ENVIRONMENTAL COMMITTEE MEETING

January 7, 2026

Subject: Review of redevelopment plans for 424 Butler Ave. E.

Review submitted plans for the redevelopment of the 424 Butler Avenue East property.

DRAWING Nº
C-1

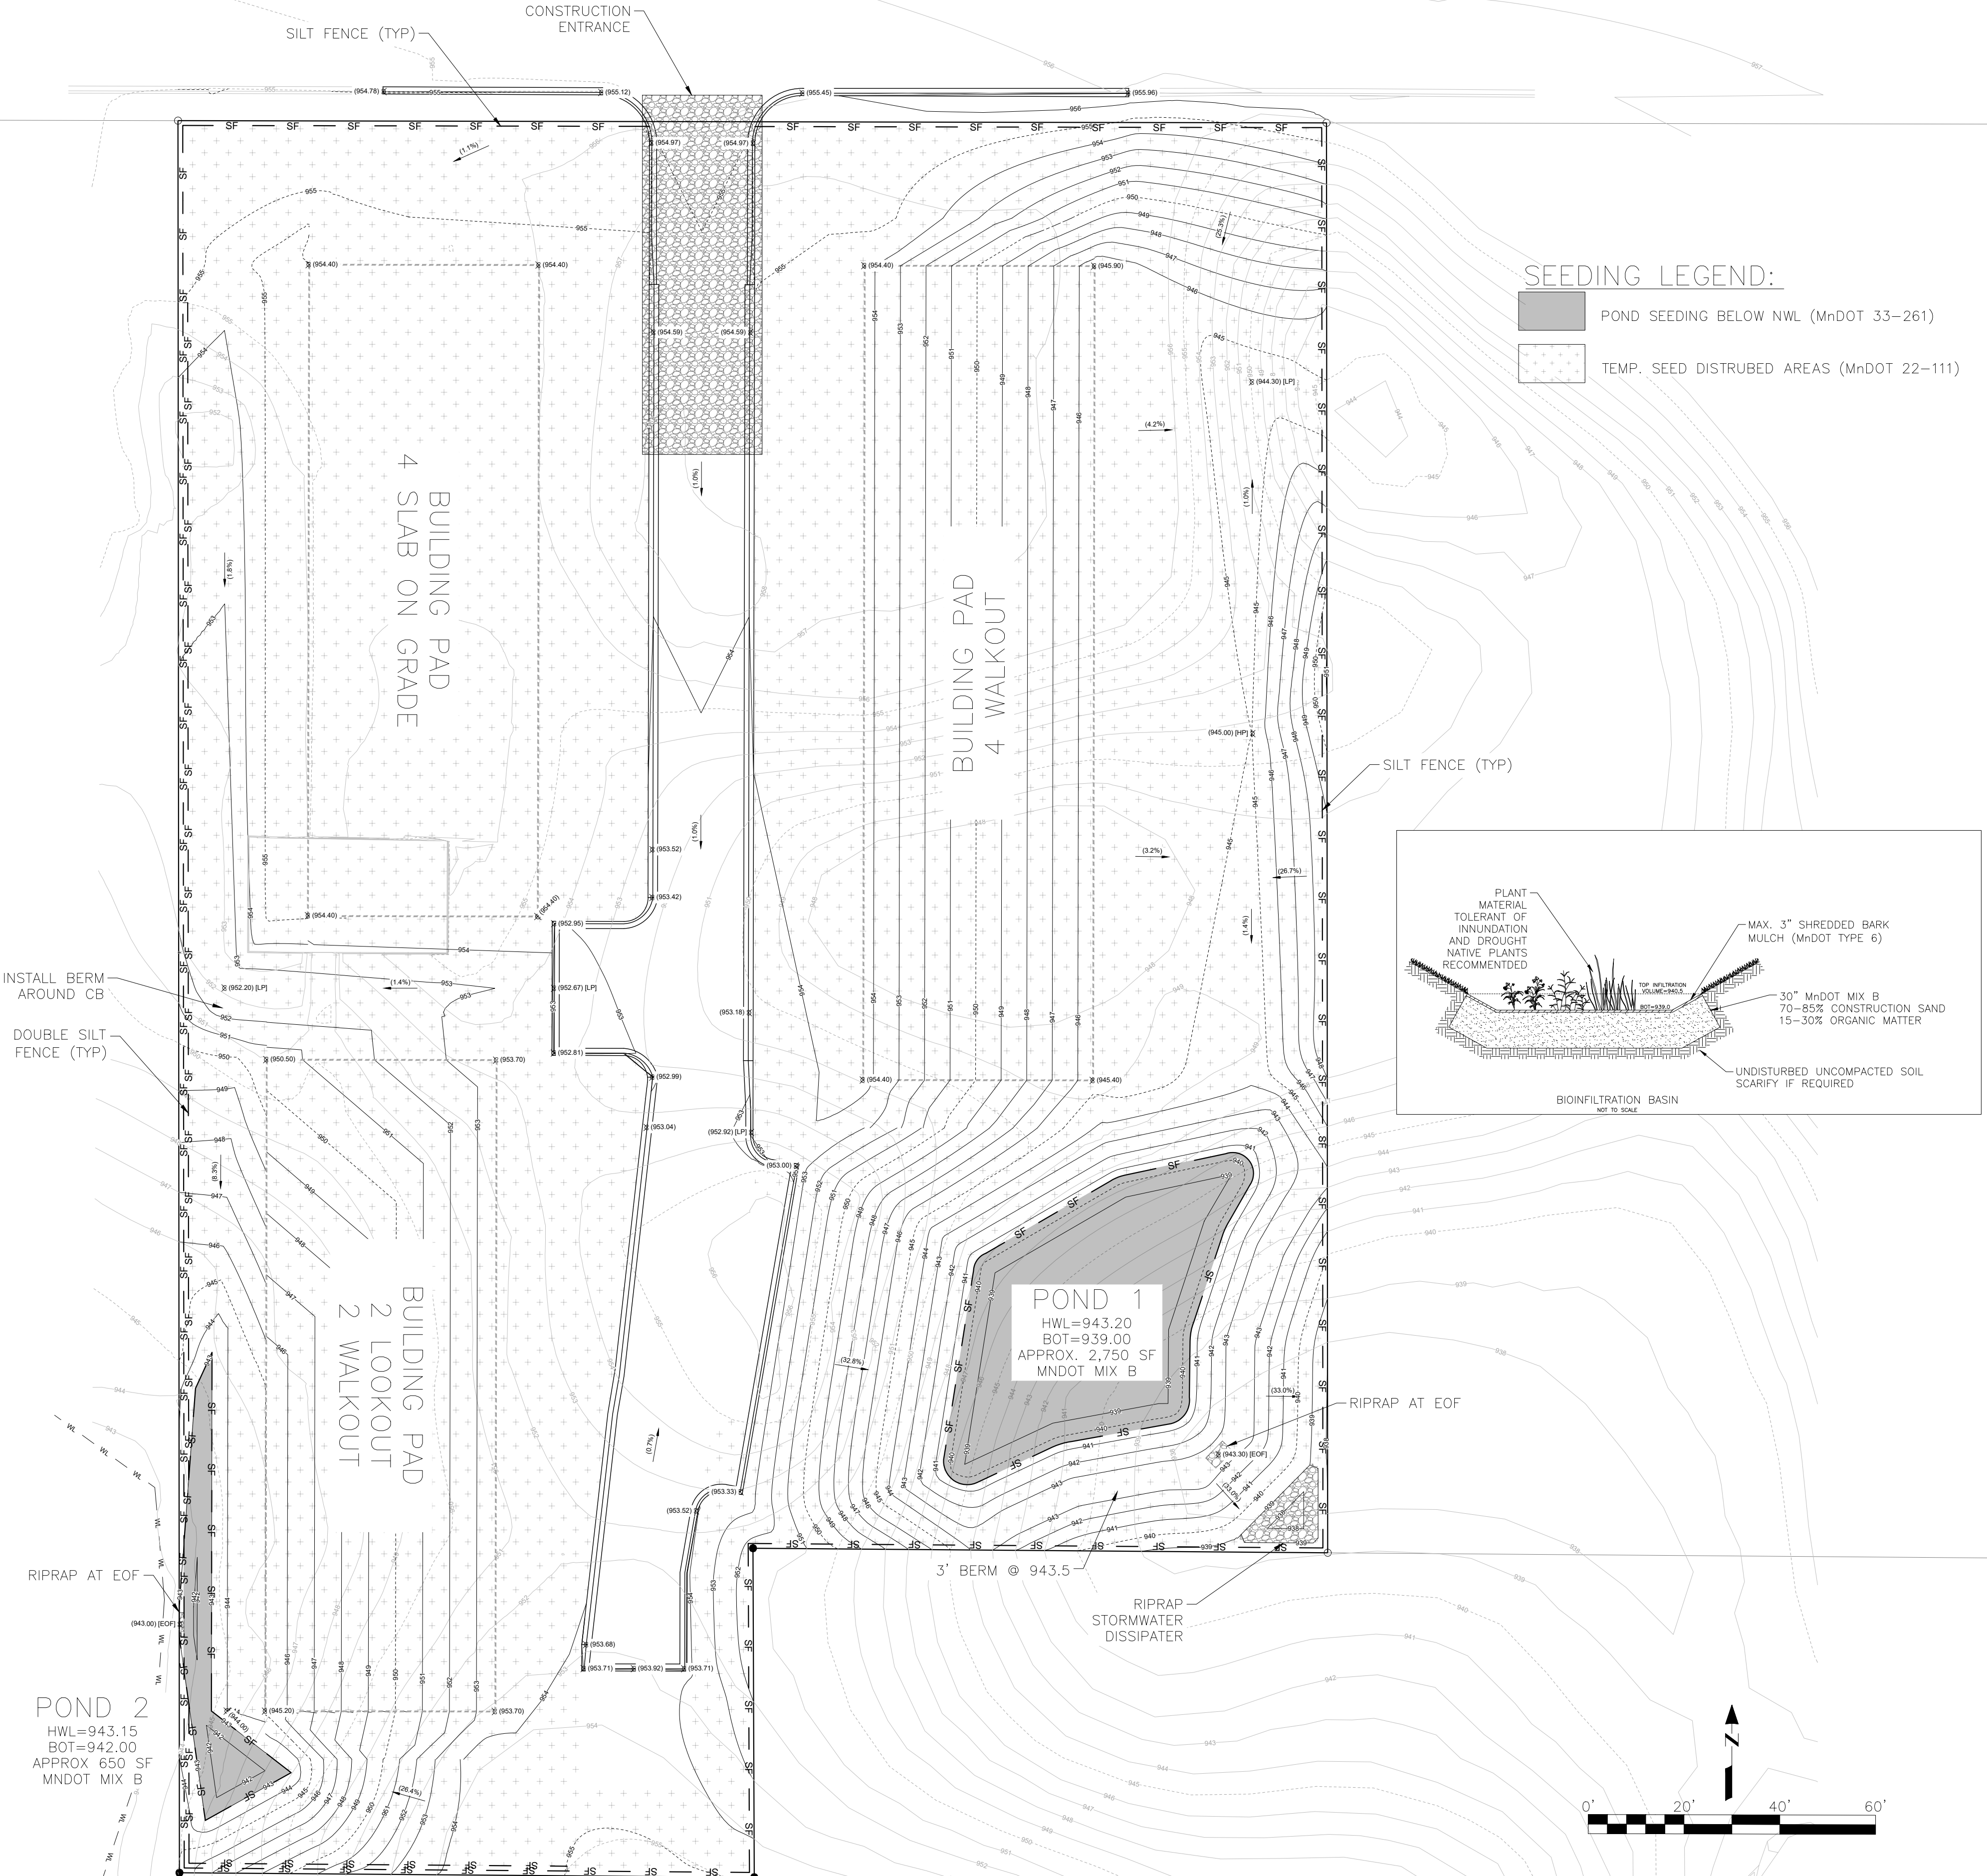
The submitted plans detail the removal of all trees on site, as the site will need to be re-graded to ensure sufficient drainage. Page C-1 of the submitted plans shows further details on the type and status of the existing trees, but a summary of the removals is included below.

When trees are removed as a part of the site plan process, at least 30% of the quality trees (at least 2.5 cal. in.) must be replaced. Based on the submitted plans, the minimum replacement requirement calculates to 359 inches (roughly 144 trees if measuring at 2.5”).

DRAWING N^o
C-3

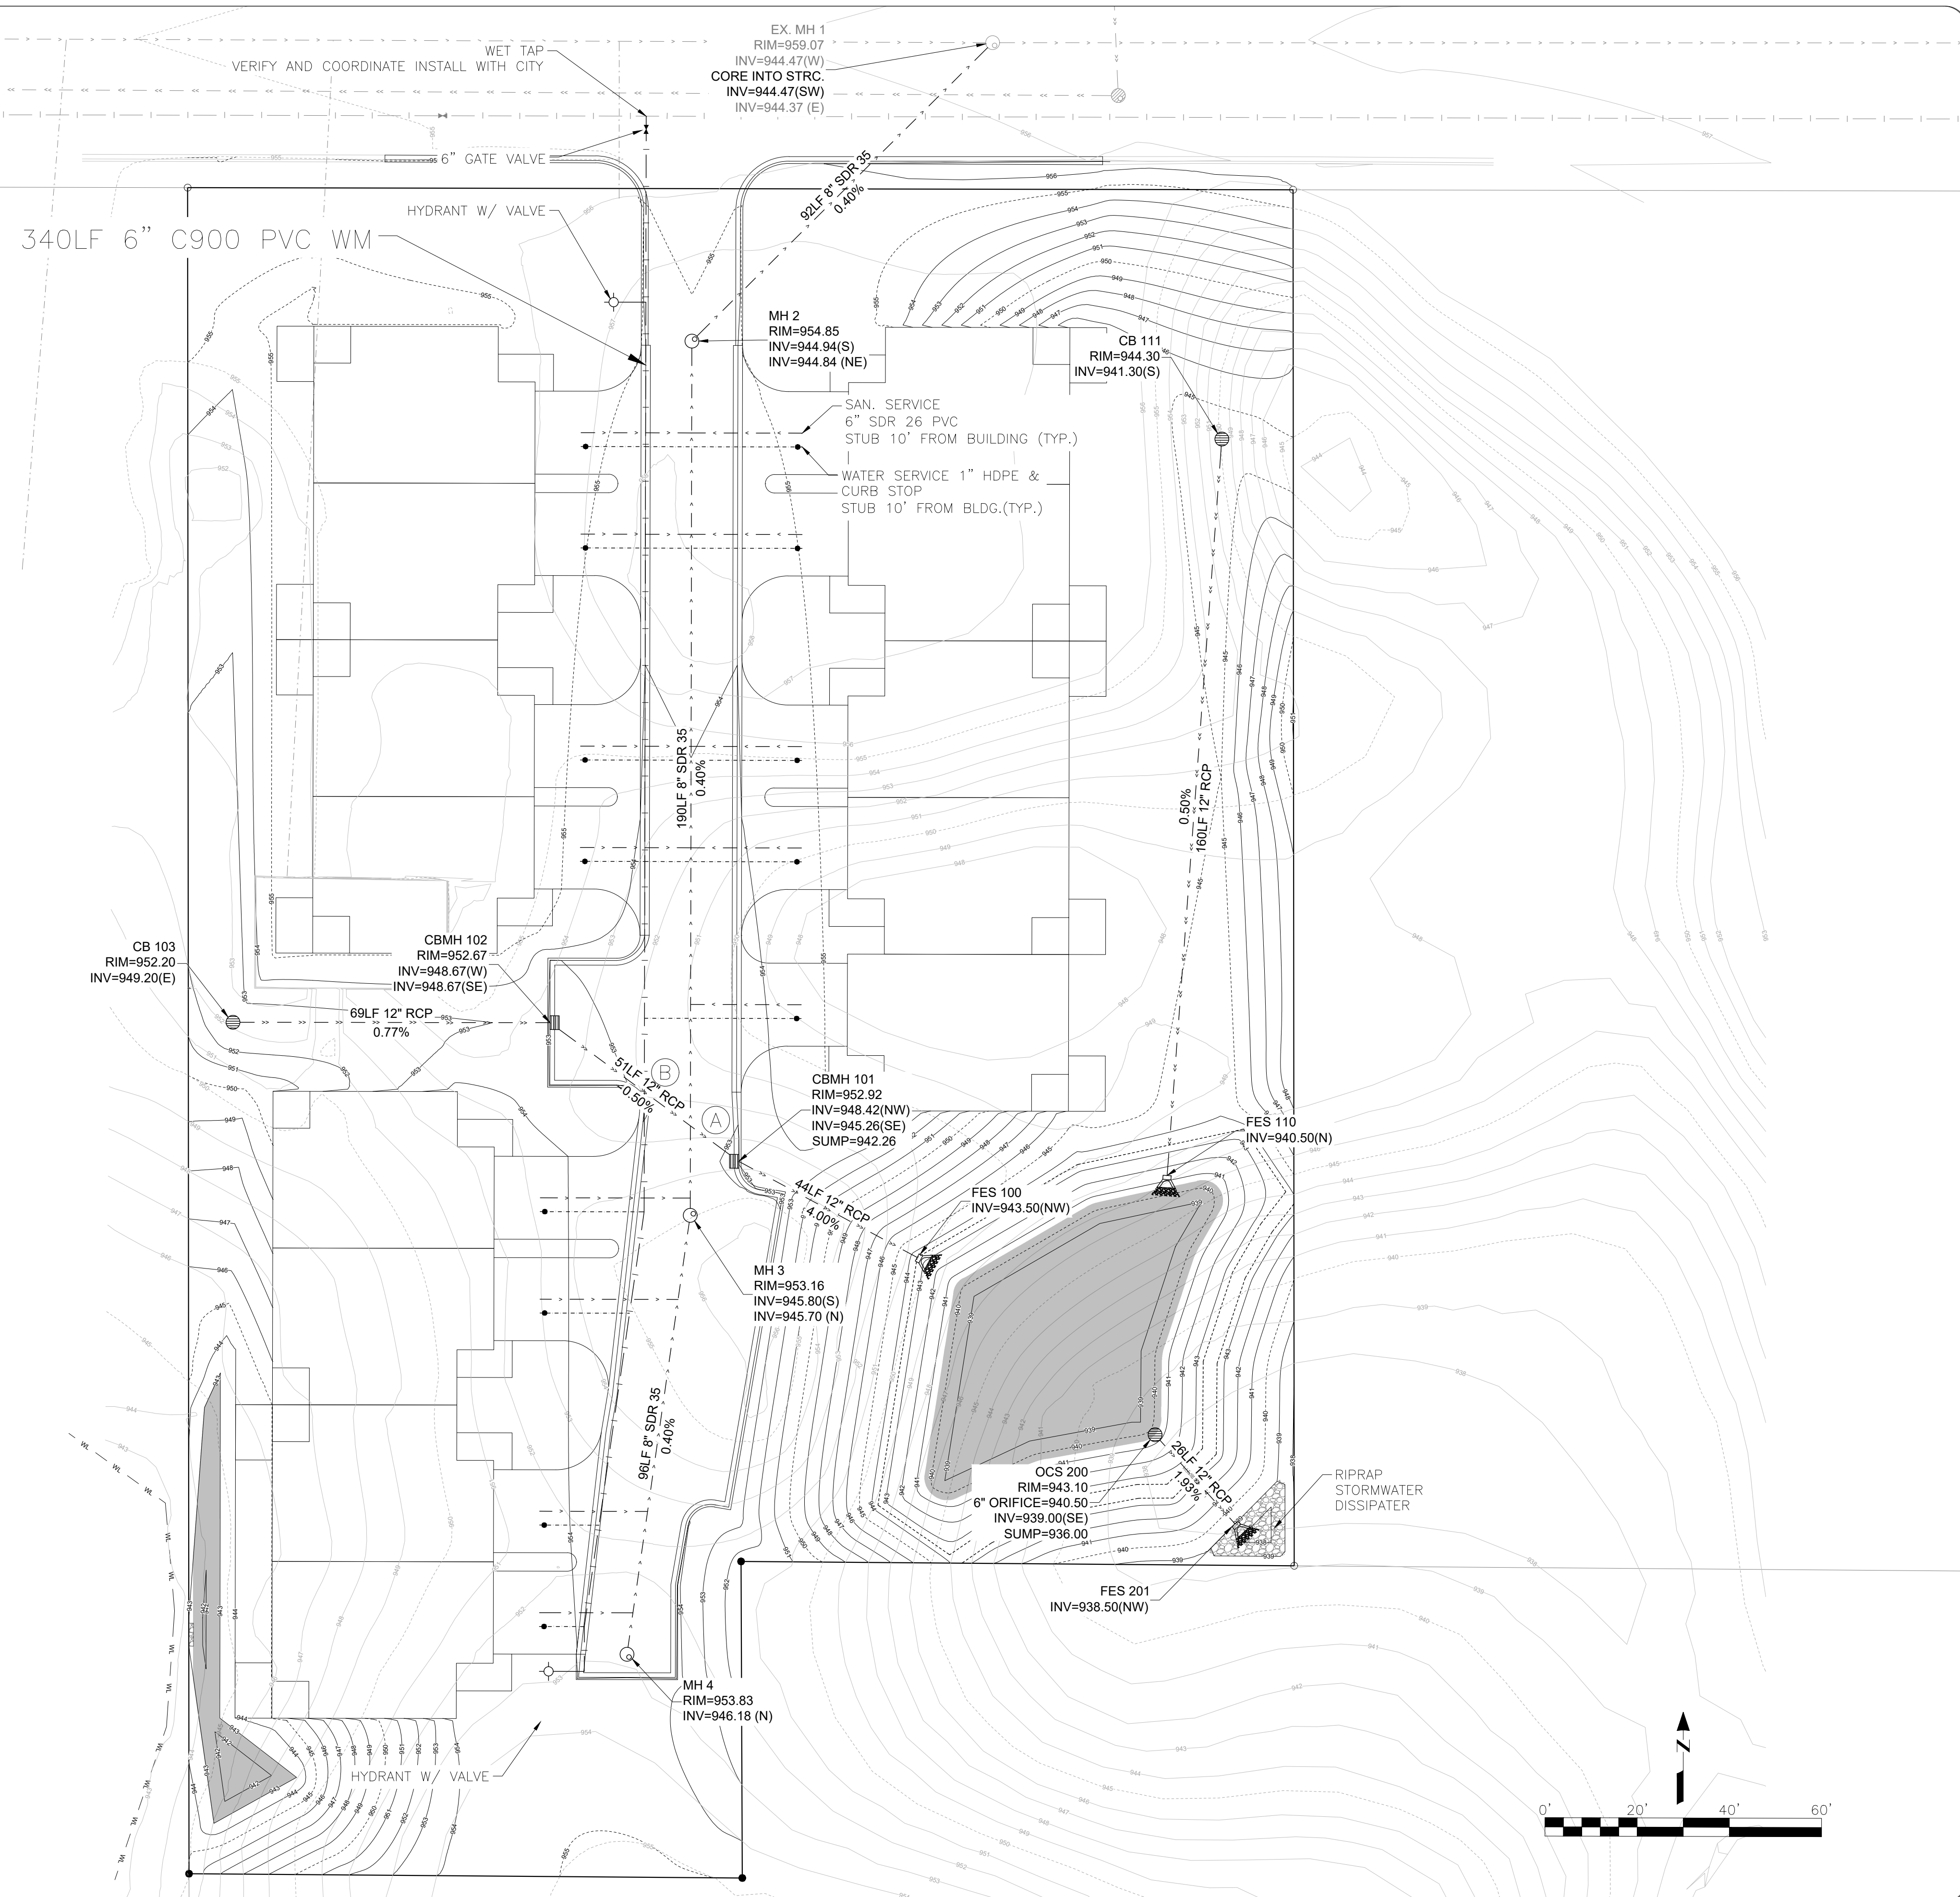
The majority of the stormwater from the site will be filtered through the biofiltration basin in the southeast section of the site, with a small portion also draining to the southwest. Final site grading can be seen on page C-3 of the included plans.
